## Agenda Item #5

### Certified Record 2026-30-CA

960 Dauphin Street

After-the-fact approval to remove original doors, transoms, and sidelights from the south façade and replace with new wood doors that do not match existing.

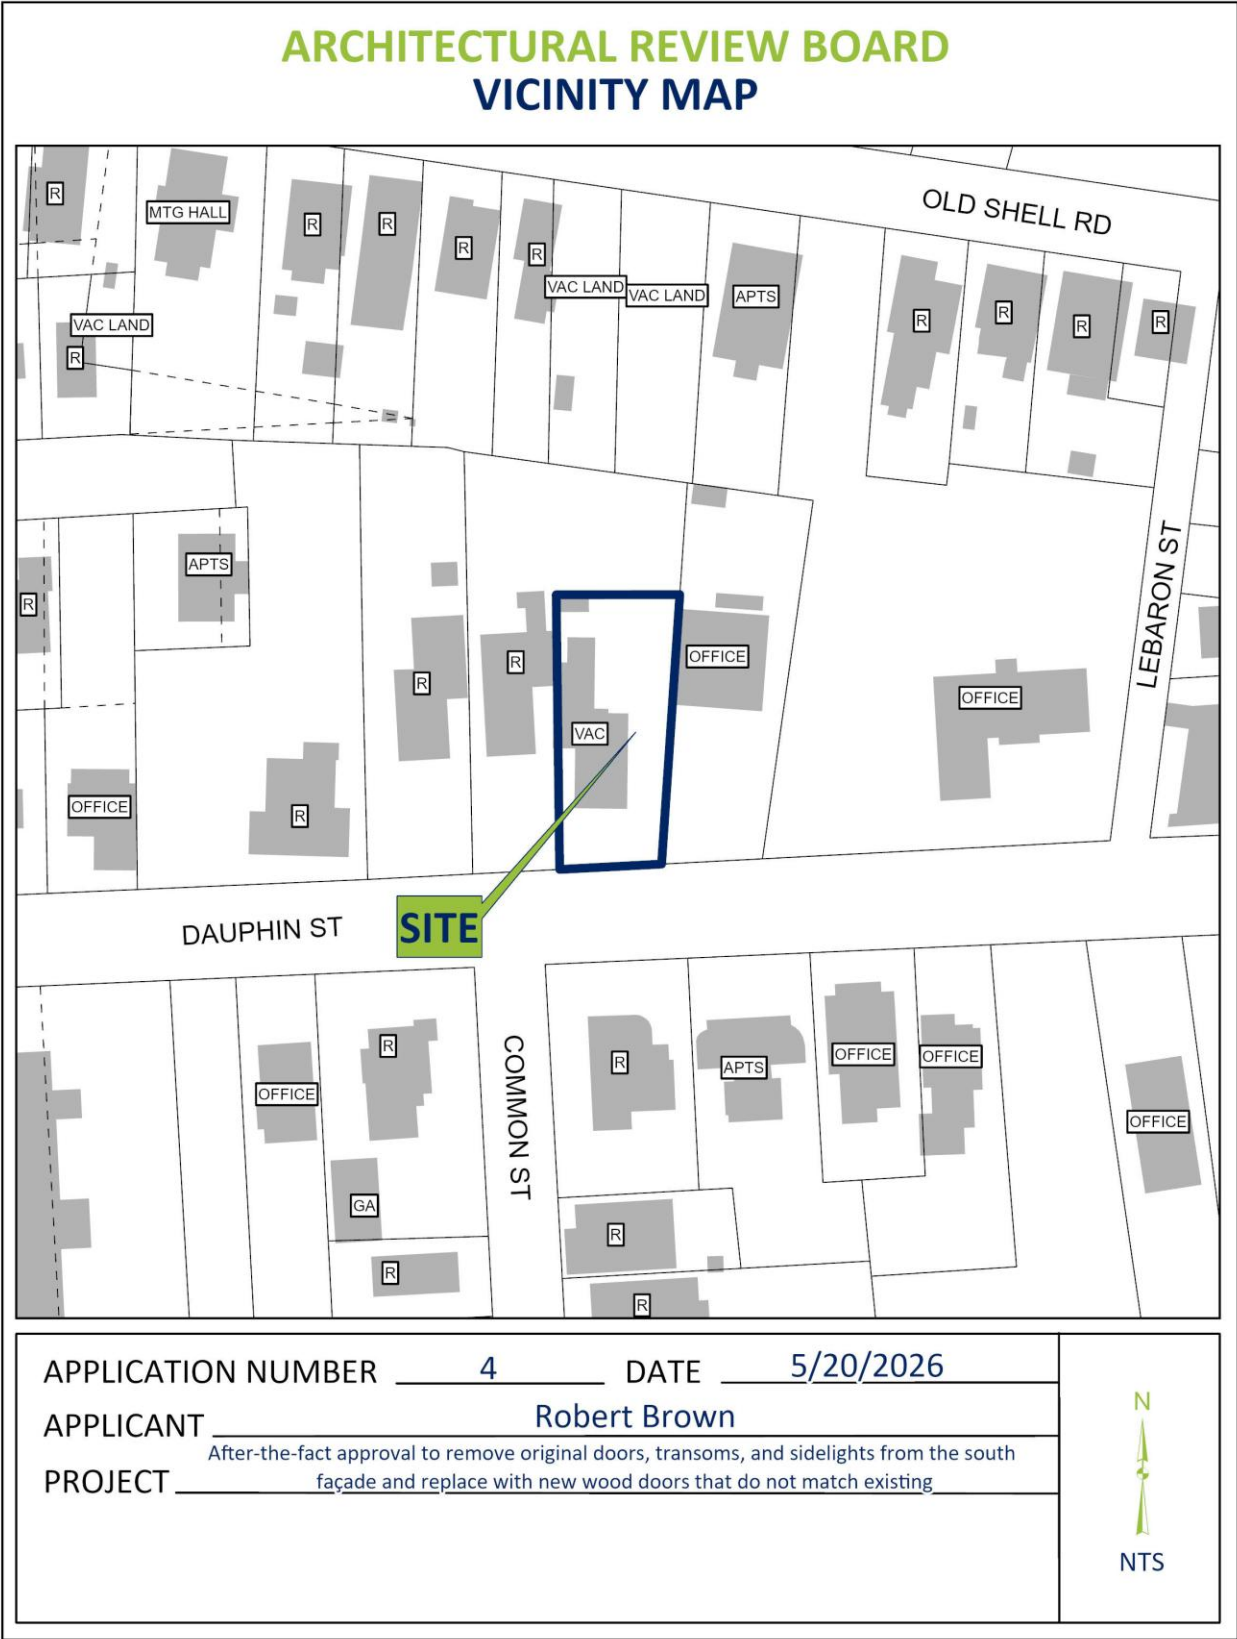
The CAD drawings submitted do not replicate the intricate detail of the historic surround. They also significantly alter the relative proportions of the door, transom, and sidelights. The neoclassical pilasters on either side of the door are not present at all in the new drawing. Instead of the tripartite transom of the original, the proposed drawing has a single 4-light transom. The door has been simplified, and its 1-over-1 wood panels are far more typical of the early 20<sup>th</sup> century than the c. 1860 construction date of the subject property. The dentil molding is entirely out of scale. While the new design would be a significant improvement over the current multi-light French doors, it does not faithfully replicate the original Italianate door and surround.

As the Guidelines clearly state, that replacements of known historic details must “match the original in profile, dimension, and material (5.19).” Since the exact style and detailing of the original door and surround is well documented, the only appropriate reproduction, according to the *Guidelines*, is one that fully and faithfully replicates the original. The proposed design does not meet this standard.
